Subject: June 2010 Inspection Report, Cameco Resources, Permits 603 and 633

**JUNE 2010 INSPECTION REPORT
DISTRICT 1/LAND QUALITY DIVISION**

COMPANY: Cameco Resources (CR), Highland Ranch, Permit #603
& Smith Ranch, Permit 633

FIGURE 1: CHECK DAM INSTALLATION EXAMPLES

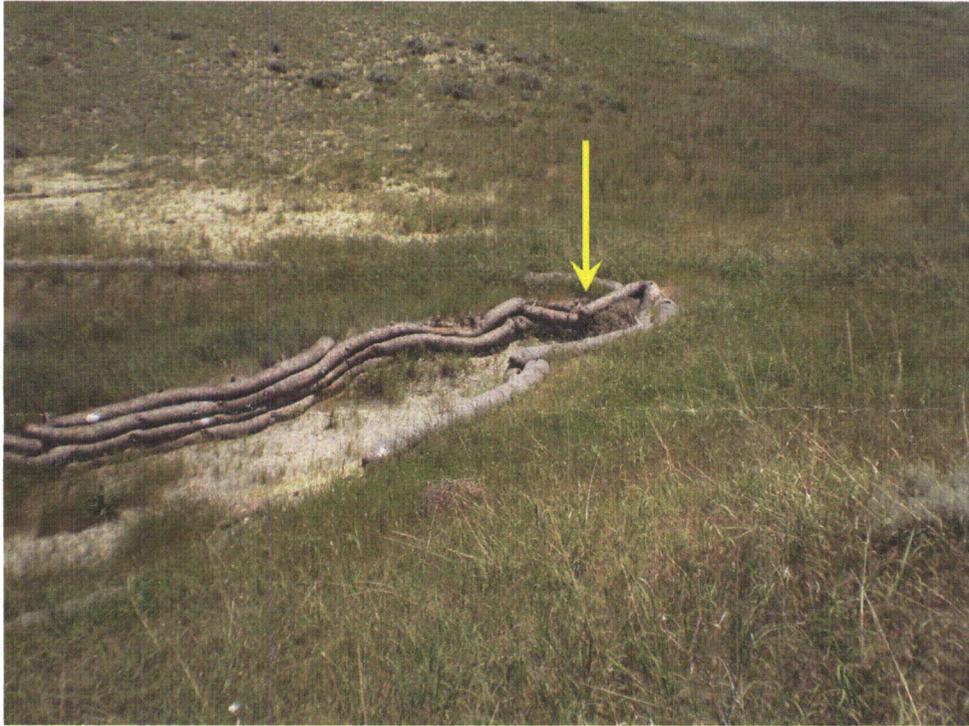
in-place after filling to the height of the roadbed. Considering that these structures are likely to remain in-place for many years, LQD recommended the replacement of the hay bale check dams with properly constructed rock check dams. The rock check dams should be installed with a low-flow point in the center, and used to provide long-term channel stability to allow the development of a densely vegetated roadside ditch. See attached Figure 1 for installation example drawings. CR should leave sediment deposition in-place, and hand seed all deposition upstream of the structures to encourage the development of a vegetated ditch.
